# VILLAGE OF ORLAND PARK

### Plan Commission

Tuesday, March 5, 2019

[2018-0742](#) Ashburn Baptist - Teen Addition - Development Petition for Rezoning, Site Plan, Elevations, Landscape Plan, Special Use Permit

J.J.	ISSUED FOR PERMIT
▲	REVISIONS
DRAWN BY:	MAM / RAM
APPROVED BY:	GCN
SCALE:	AS NOTED
DESCRIPTION:	LANDSCAPE PLAN
SHEET NO.	L1.1

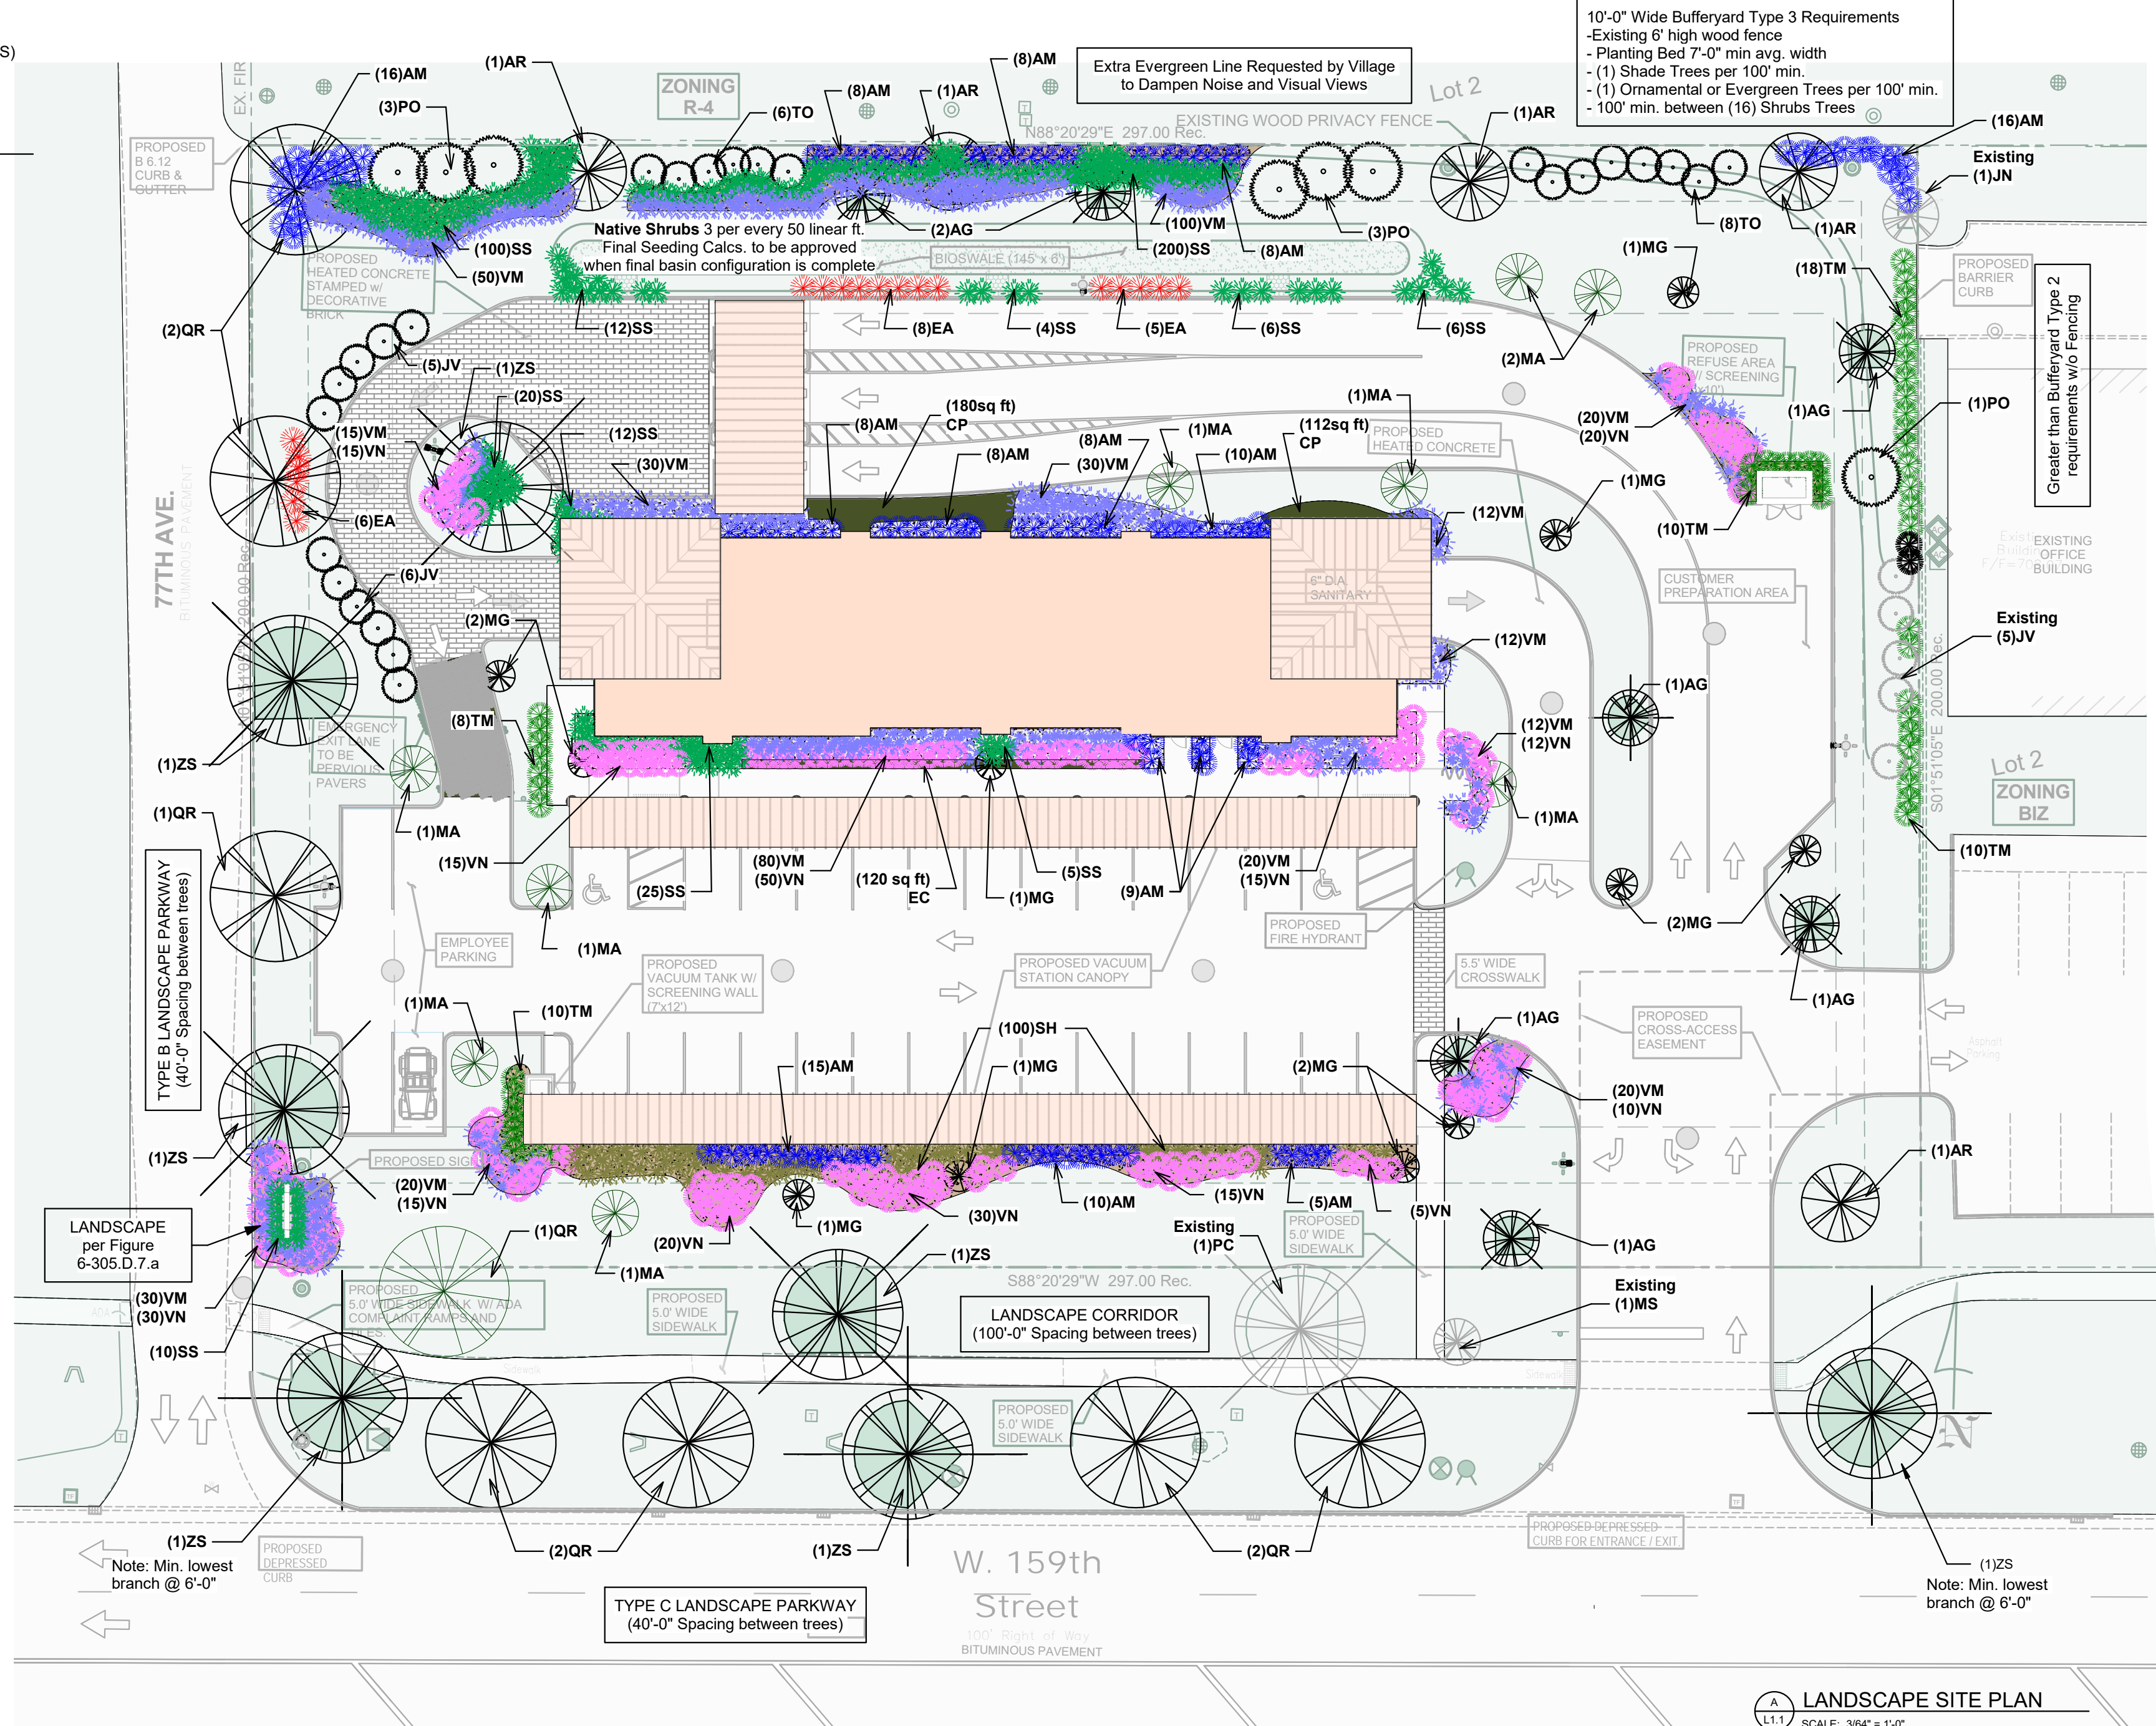
I move to recommend to the Village Board of Trustees approval of the Preliminary Landscape Plan, titled "New Automated Car Wash Facility - Voda", prepared by Neri Architects, PC, Sheet L.1.1, dated January 18, 2019, with the following conditions:

1. Submit a final landscape plan meeting all Village Codes and all required supporting documentation addressing all outstanding landscape items in conjunction with the final engineering submittal.
